AEP:NRC:0773S

Donald C. Cook Nuclear Plant Unit Nos. 1 and 2
Docket Nos. 50-315 and 50-316
License Nos. DPR-58 and DPR-74
ADDITIONAL INFORMATION ON AND REQUESTS FOR DEVIATIONS
FROM REGULATORY GUIDE 1.97, REV. 3 RECOMMENDATIONS

I&MECo Responses to EG&G Idaho, Inc.
Evaluation of Regulatory Guide 1.97, Rev. 3
Compliance at the D. C. Cook Nuclear Plant
Unit Nos. 1 and 2

CONTAINMENT SPRAY PUMP FLOW VS. DISCHARGE PRESSURE

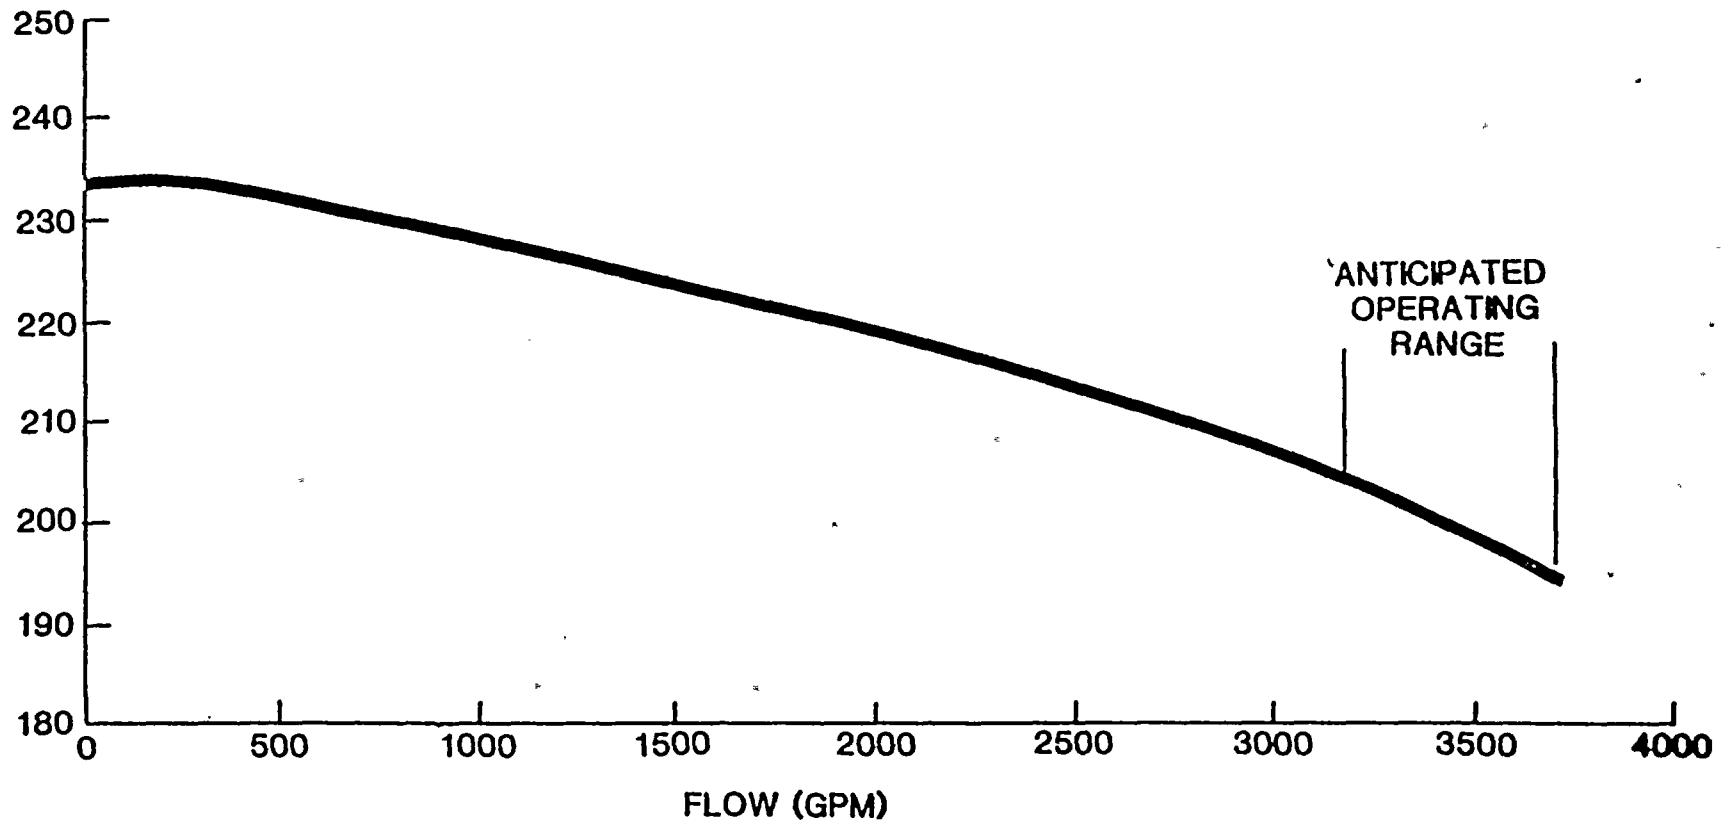
"Regulatory Guide 1.97 recommends instrumentation for this variable with a range of 0 to 110 percent of design flow. The Cook station has upper containment spray flow instrumentation, however, the licensee monitors the spray pump discharge pressure and the containment pressure, stating that with this instrumentation, the operator will be able to determine adverse containment conditions.

"The alternate instrumentation provided by the licensee sounds like a reasonable approach; however, the licensee should provide the NRC with the relationship between the pump discharge pressure and the pump flow rate as a basis for this deviation."

When operating normally, each containment spray pump will deliver 3200 gpm (design flow) at 490 ft. TDH. As requested by EG&G we have attached to this response a curve showing containment spray pump flow as a function of pump discharge pressure (drawing No. HXP87055JW-1).

The attached curve indicates the expected range of operation for the containment spray pumps. This operating range stems from consideration of pump suction head, containment pressure, and pump operating characteristics. Routine surveillance of spray pump operation is performed to ensure that, if containment spray is required, the pumps will operate in the indicated area of the flow curve and hence provide the necessary flow to the containment spray system. The reactor operators can, therefore, verify proper

containment spray flow by monitoring spray pump discharge pressure to confirm that it is within the expected range.

Based on the above, we request a deviation from the Regulatory Guide 1.97, Rev. 3 recommendation for containment spray flow instrumentation.

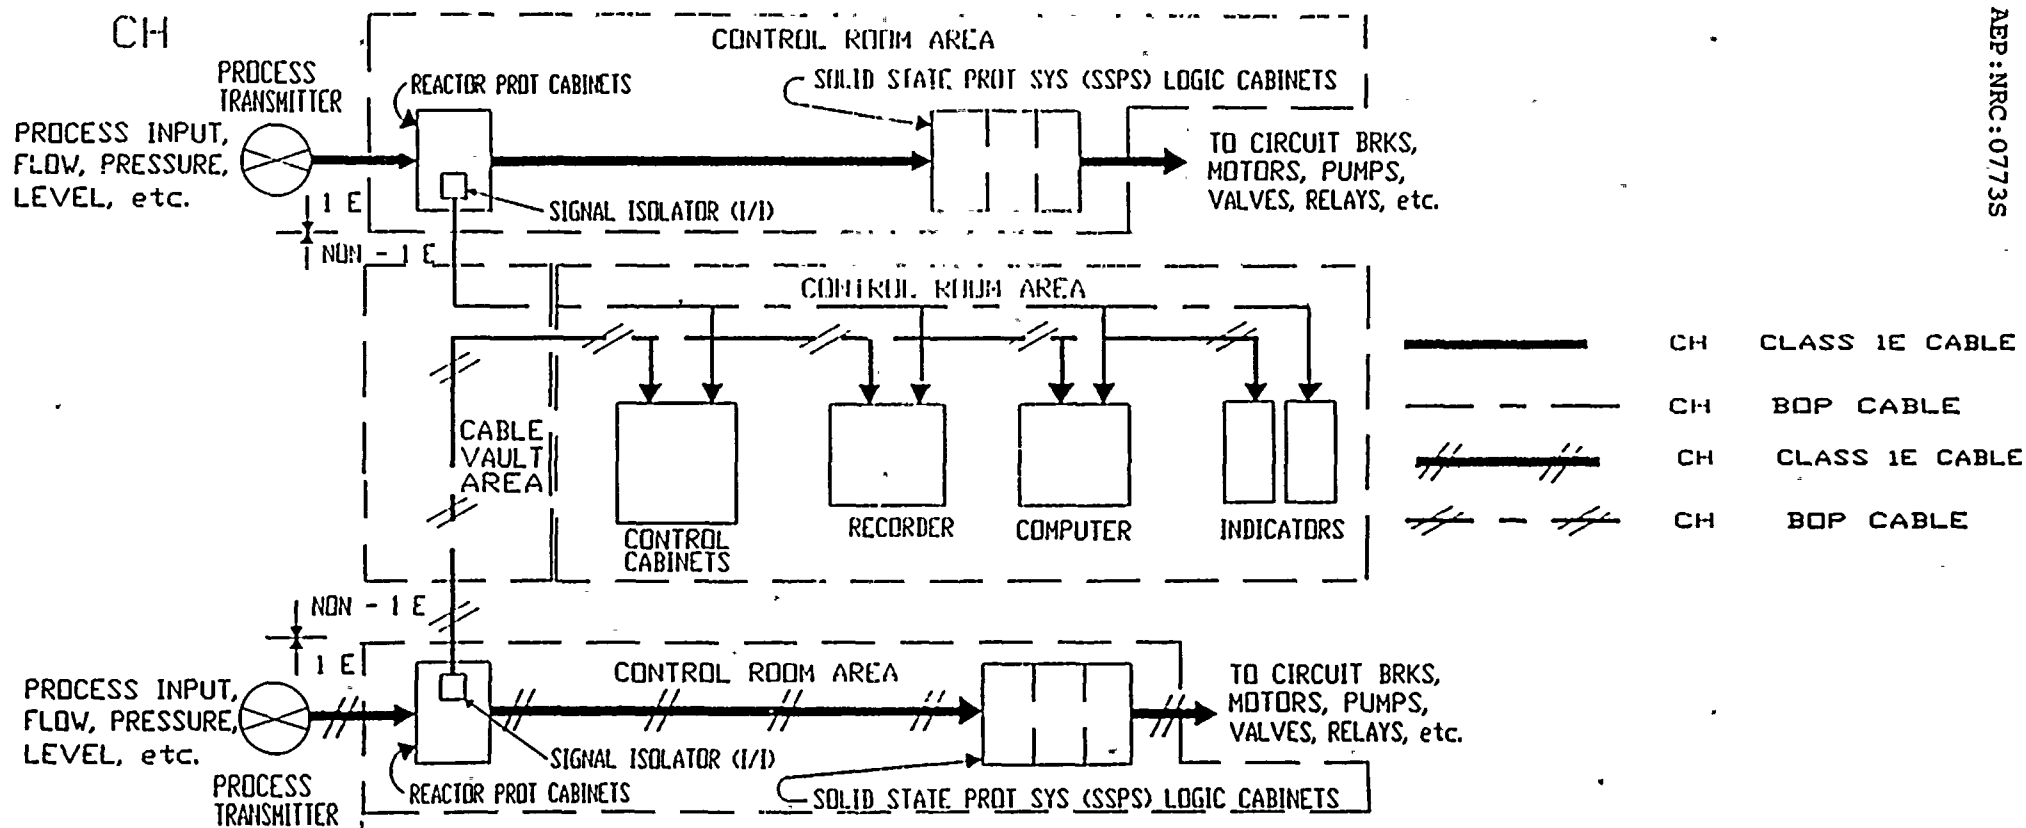
We believe it is necessary to request a deviation from the physical separation recommendations of Regulatory Guide 1.97, Revision 3, dated May 1983 for Class 1E electrical systems. These separation recommendations apply to Category 1 instrumentation used for post-accident sampling and monitoring.

The attached figure is an electrical schematic that shows a typical cable and hardware configuration for redundant PAM channels. Other PAM channels may also feed the cable vault area and control room area but are not shown for the sake of clarity. This configuration reflects our originally licensed design. This design was completed prior to the issuance of the NRC guidance regarding physical independence of electrical systems (Regulatory Guide 1.75, September 1978) and the associated IEEE standard for separation of Class 1E equipment and circuits (IEEE standard 384-1974).

Physical separation (of both electrical cabling and hardware) is maintained between the redundant Reactor Protection Set Channels. Isolation between the Protection Set Channels and the Balance of Plant (BOP) cabling used by the PAM signals is achieved by means of signal isolators (I/I) located in most instances in the Reactor Protection Cabinets. These cabinets are located in the control room area. The BOP interconnecting cabling between these cabinets and the various PAM readout devices is routed through the cable vault area and then back to the control room. The redundant PAM signal cables in the cable vault area and in the control room are not physically separated. Also, the redundant PAM readout devices are not physically separated. There are also some cases of redundant PAM single cabling feeding a single readout device (recorder or computer).

We believe the above design configuration is consistent with our previously licensed control room design, and also represents the methods by which we intend to install future modifications associated with Regulatory guide 1.97. For this reason, we request preliminary staff comment on this request for deviation by July 15, 1987.
